UNITED STATES PATENT AND TRADEMARK OFFICE

| APPLICATION NO. | FILING DATE | FIRST NAMED INVENTOR | ATTORNEY DOCKET NO. | CONFIRMATION NO. |
|---|-------------|----------------------|---------------------|------------------|
| 10/638,849 | 08/11/2003 | James Xixian Wu | SP-1076.2 US | 4449 |

Office Action Summary

DETAILED ACTION

FIG. 1 OF THE INSTANT APPLICATION

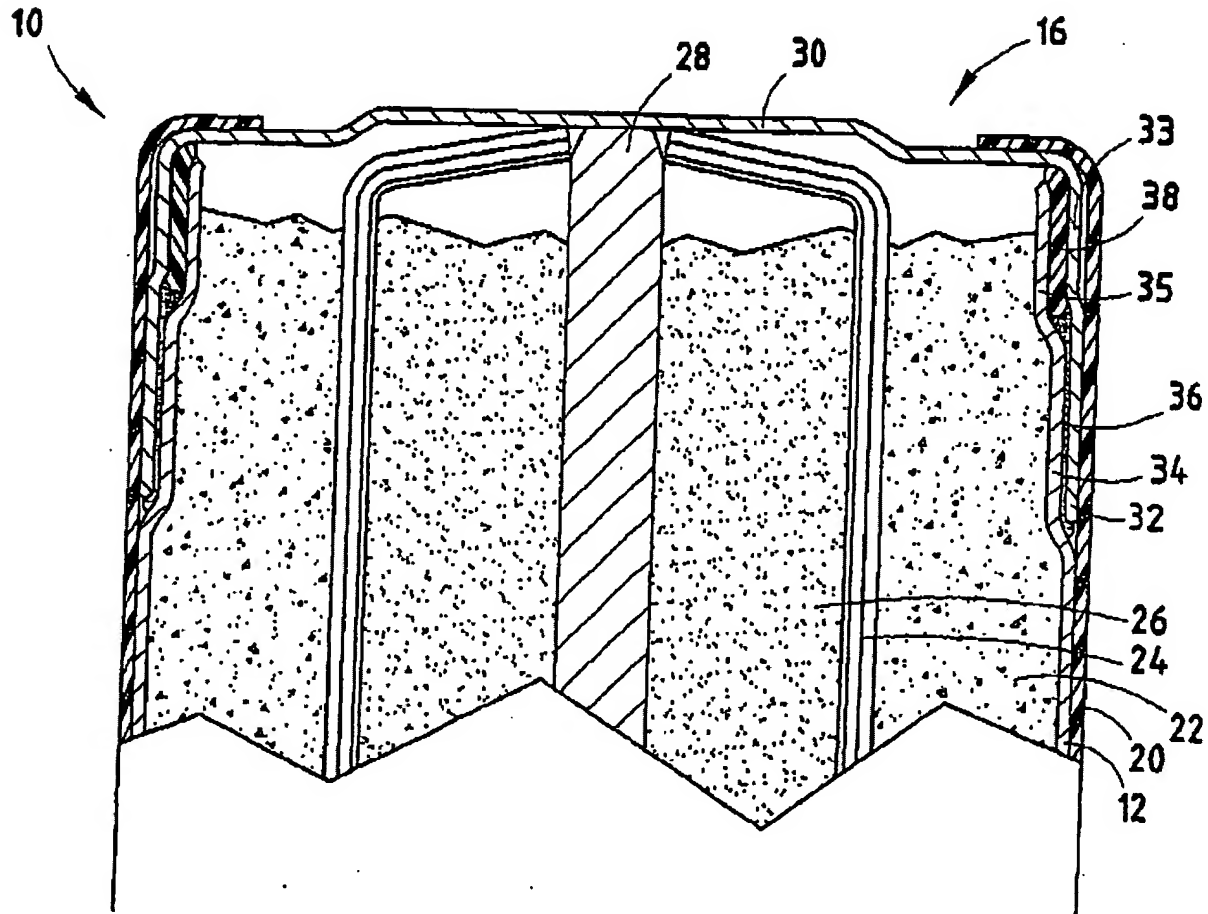
Applicant's own disclosure of to Fig. 1 shows that the cover 30 which is cup-shaped having bent edges is placed in a sealing arrangement with the container. The disclosure of Riedl is identical to this arrangement as claimed (discussed above). A complete review of the original disclosure of the instant application reveals that Applicant's own disclosure recognizes this arrangement to be exemplary of a non-crimped design (see Fig. 1 and paragraph bridging pages 6 and 7 of the instant Applications own disclosure).

Provided herein is a side-by-side comparison between Fig. 1 of the instant application, an admitted embodiment of a non-crimped arrangement between the cover and container of a battery and Fig. 3 of Riedl.

In Fig. 1 of the instant application, reference character 30 corresponds to the cover and 12 to the container. As described in the paragraph bridging pages 6 and 7 of

the instant application, this arrangement is a non-crimped arrangement between the cover 30 and container 12.

FIG. 3 of RIEDL

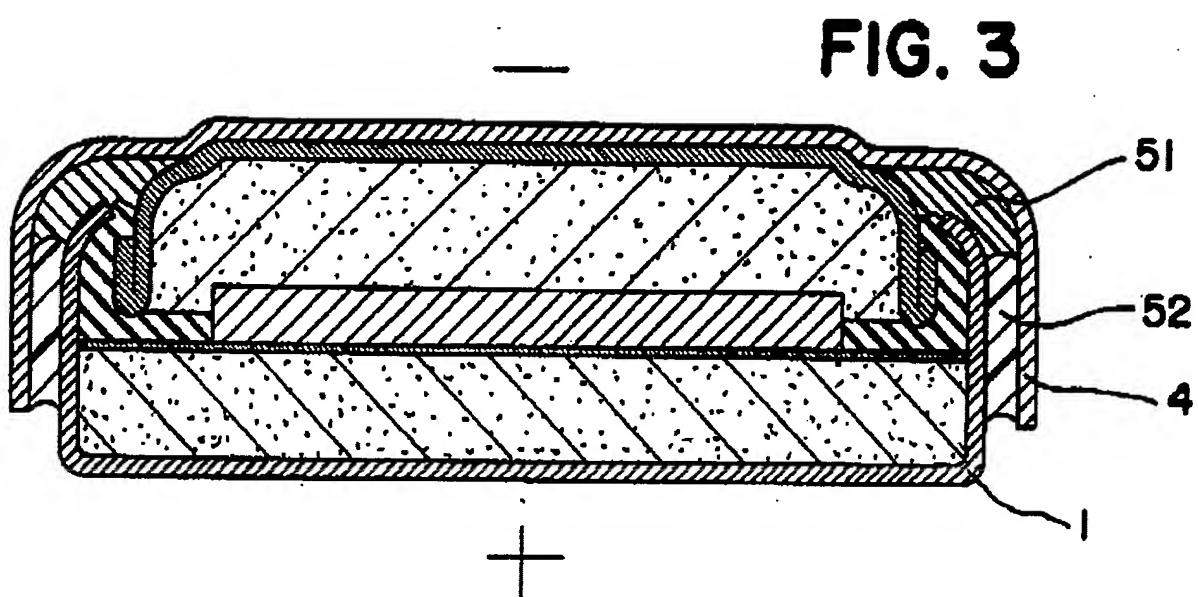
In Fig. 3 of Riedl, reference character 4 corresponds to the cover and 1 to the container. This arrangement, structurally identical to the cover and container arrangement with respect to the claimed invention is also understood to be non-crimped arrangement between the cover 4 and container 1.

It should be apparent for the reasons set forth above, and from the analysis of the corresponding figures below, that the prior art in fact anticipates the non-crimped structure. Therefore the rejection stands.
